UNITED STATES PATENT AND TRADEMARK OFFICE

APPLICATION NO.	FILING DATE	FIRST NAMED INVENTOR	ATTORNEY DOCKET NO.	CONFIRMATION NO.
10/814,976	03/31/2004	Kazuo Banju	P/3541-56	8684

Office Action Summary

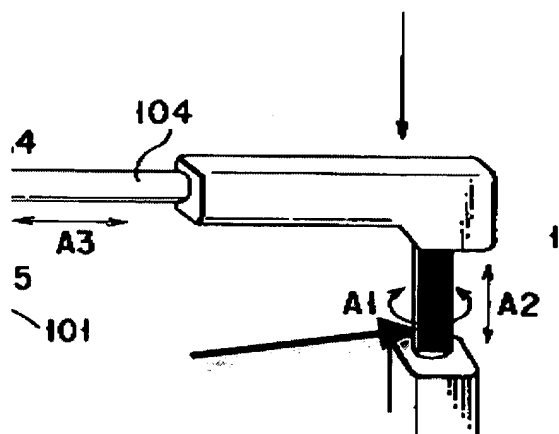
Referring mainly to Figure 9, and regarding claims 1 and 6, Mizuno discloses stereoscopic endoscope (105, col.19, lines 8-10), a support unit (robot 104) which supports the endoscope (Fig.9), and a rotation mechanism incorporated in the support unit and including a rotary shaft (highlight in the picture below) which is substantially parallel to an optical axis of

the objectives (note in Figure 9 that rotary joints near the endoscope that allow rotation around A4 and A5 will allow the endoscope

retain a vertical (with respect to gravity) orientation, the same as the rotary shaft), the rotation mechanism supporting the instrument such that the instrument can rotate about an axis of the rotary shaft (note A1). Mizuno et al. fails to disclose the particulars of the stereoscopic endoscope. Takahashi shows just one example of what was known in the art at the time of the invention. Takahashi teaches a stereoscopic endoscope including pair of objectives (3a,3b), optical devices (4a,4b) corresponding to the objectives, and a stereoscopic camera (2a,2b). Given that Mizuno et al. fails to disclose the particulars of the stereoscopic endoscope, it would have been obvious to one of ordinary skill in the art at the time of the invention to have “filled in the gaps” from what is known to the ordinary skilled artisan. Thus, it would have been obvious to have used a known prior art structure, such a Takahashi, as the stereoscopic endoscope of Mizuno et al.

As to claim 2, there would inherently be frictional resistance limiting rotation of the rotary shaft. As to claim 3, note other joints (at 118 for instance) with other structure engaged

therewith (note col.9, lines 30-34). Inherently, the rotary shaft would rotate even when other joints are engaged with the engagement means. As to claim 5, although unclear, note other joints that allow rotation (e.g., 118).
